Mississippi Valley Conservation Authority

Casey Creek Flood Plain Mapping Study

Draft January 2020
Final May 2021

Appendix H

Figure 5: Casey Creek Sub-catchment Delineation

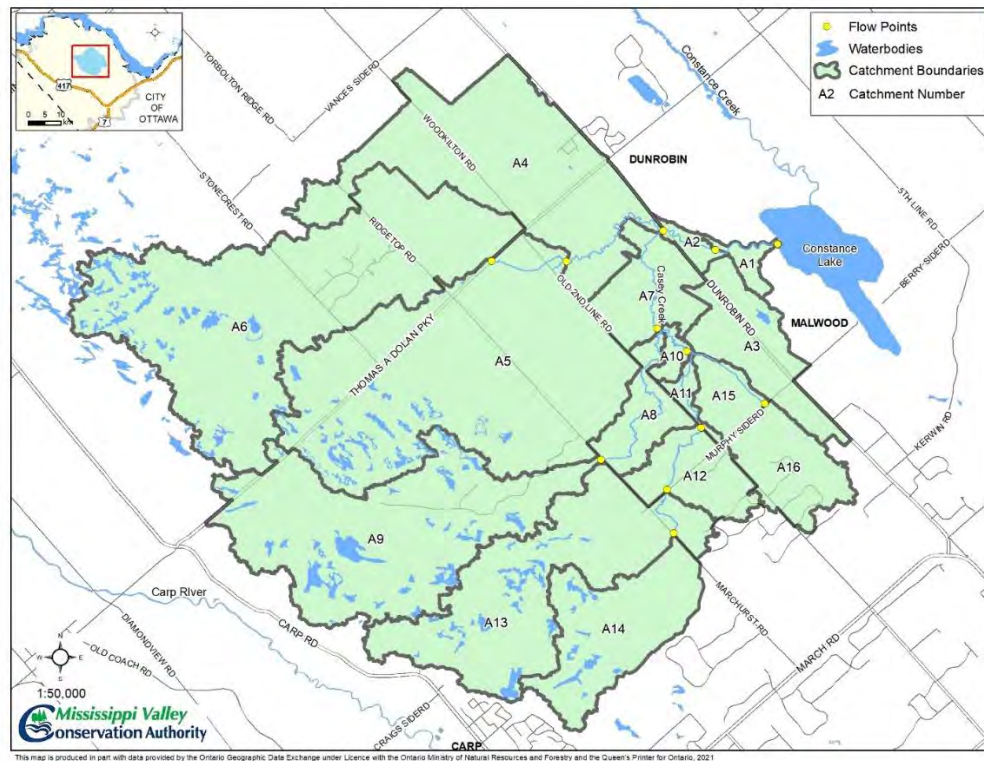
- Figure 5 on page 12 and Table 1 on page 14 of the draft report includes drainage areas for the eight subcatchments delineated which range between 173.9 ha and 2847.4 ha. It is recommended MVCA complete more refined drainage area delineations (smaller subcatchments) to assess the potential impact on peak flows. For example, area A2 has a large drainage area of 2847.4 ha which appears to have variable hydrologic characteristics across the subcatchment. The north western portion is more predominantly wetland and wooded areas while the north eastern portion is more predominantly agricultural land (as shown on Figure 2). Considering each area could have a different hydrologic response it is warranted to check the associated impact to peak flows through further discretization.

node 3 it is noted that routing occurs through the center of subcatchment 6 and the peak flow from that subcatchment is added at the downstream end. It is assumed portions of subcatchment A6 will drain into the tributary prior to node 3. As such the model may underestimate peak flows along this routing segment. It is recommended MVCA review this route channel command and provide due consideration to adding additional inflow points accordingly.

- Similar to the above, subcatchment A3 is added directly downstream at flow node 8, however a portion of subcatchment A3 will drain to the tributary prior to node 8. It is recommended MVCA review and provide due consideration to adding additional inflow points accordingly.

JFSA Comment	MVCA Response
Hydrologic Analysis		
1	It is recommended MVCA complete more refined drainage area delineations (smaller subcatchments) to assess the potential impact on peak flows.	A more detailed drainage area delineation was completed, the number of subcatchments was doubled in the revised hydrologic model.
2	Portions of subcatchment A6 will drain into the tributary prior to note 3. It is recommended MVCA review this route channel command and provide due consideration to adding additional inflow points accordingly	Subcatchment A6 was split into smaller subcatchments to provide additional inflow points.
3	A portion of subcatchment A3 will drain to the tributary prior to node 8. It is recommended MVCA review and provide due consideration to adding additional inflow points accordingly.	Subcatchment A3 was split into smaller subcatchments to provide additional inflow points.
4	It is recommended MVCA review the profiles of all flow paths and give due consideration to the MTO 85/10 method where applicable.	The MTO 85/10 method was utilized in the revised hydrologic model.

14	It is recommended that MVCA rather complete more detailed drainage area discretization to obtain peak flows at intermediate locations rather than prorated.	Addressed in the revised version of the hydrologic model.
15	It is noted in Section 3.2 on page 40 of the draft report that the cross-sections are oriented left to right looking downstream. The cursory review has identified this is not the case for three cross sections including 809 (River: Casey, Reach: Trib 1-DS-0), 1 (River: Casey, Reach Main-DS-1-DS-0) and 1293 (River: Casey, Reach: Main). It is recommended MVCA review cross section orientations and update the HEC-RAS model accordingly.	Cross-sections were reviewed and the flow directions were corrected in the revised hydraulic model.
16	It is noted cross section 827 (River: Casey, Reach: Main) extends into an adjacent spill area outside of the flood	A levee was added on the right side to confine the flow within the conveyance path.
